# KAMIRA AVENUE VILLAWOOD

RFI - URBAN DESIGN REPORT

JUNE 2023

BUILDING SEPARATION  
NORTH SOUTH PEDESTRIAN LANE WAY

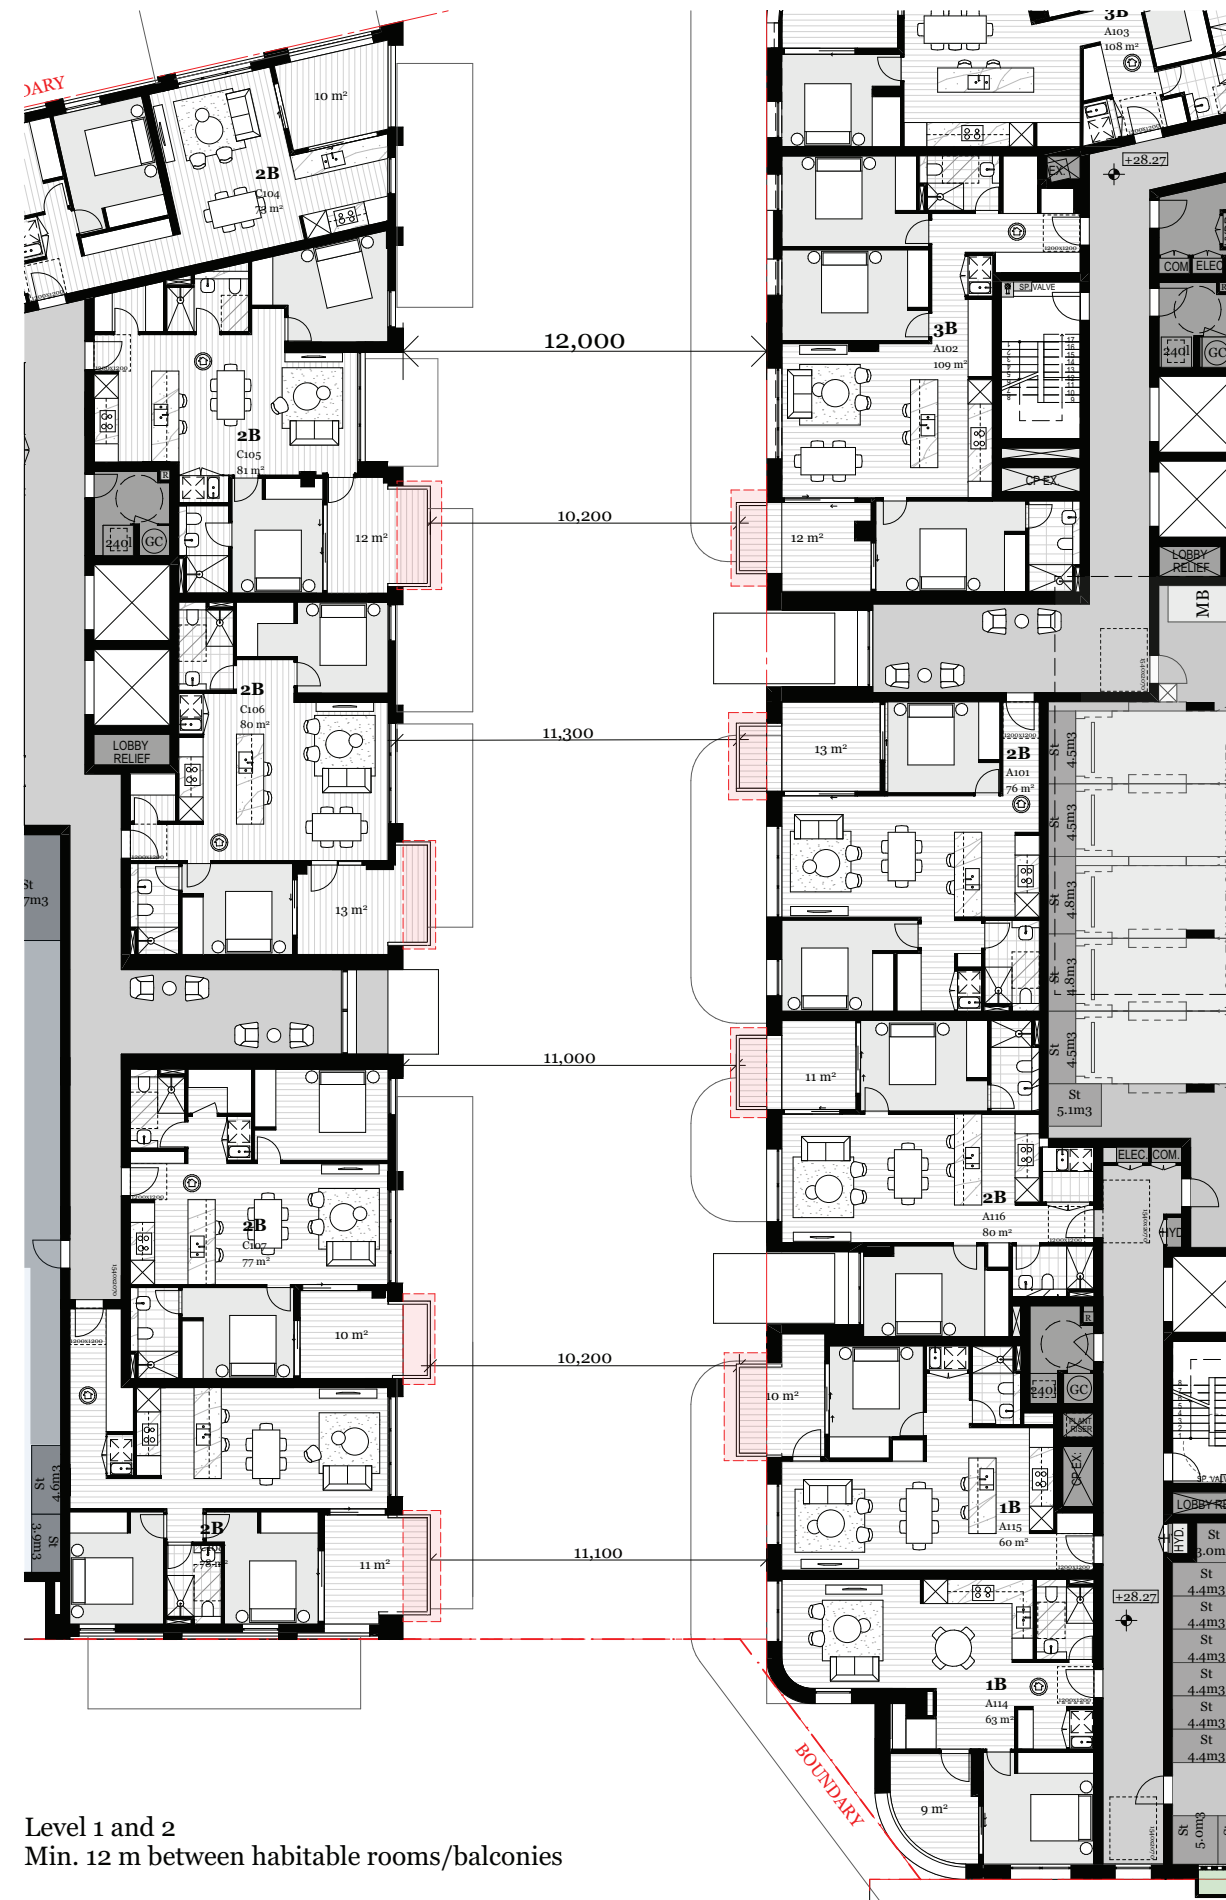
Building Separation Distances  
The proposed building separation distances do not comply with the ADG requirements: Across the new north-south pedestrian laneway balconies and windows for levels 1 and 2 face each other with less than the required 12 metres.

The balconies provide articulation and passive surveillance to the lane way.
